PARTS BULLETIN

Reference		Date
PB-157	EH060 Inverter Change	11/7/2022
Product	EH060 Inverter Part Number 13956024

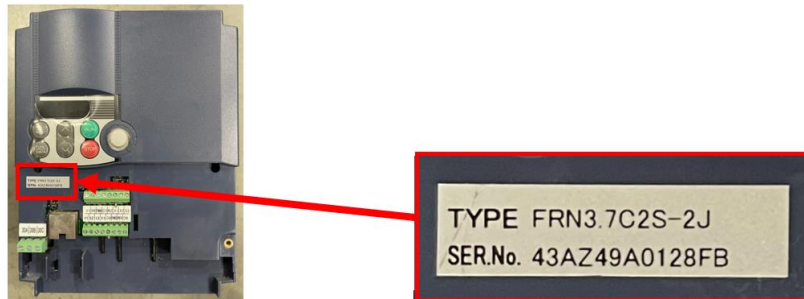
Due to supply chain issues the 200-240 VAC EH060's inverters (part number 613893) has been temporarily substituted to a new inverter (part number 13956024). This change in production machines started at serial number 2404222. The inverters for the most part look identical. To identify the inverter, look at the manufacturer's model number (TYPE) (see picture below).

There has also been a software change to allow the new inverter to properly communicate with the microprocessor. The new software (v 46 and v91) are backwards compatible. The only difference in software is based on the control types.

- The Inteli control machines will use version 46.
- The Logi and Vended control will use version 91.
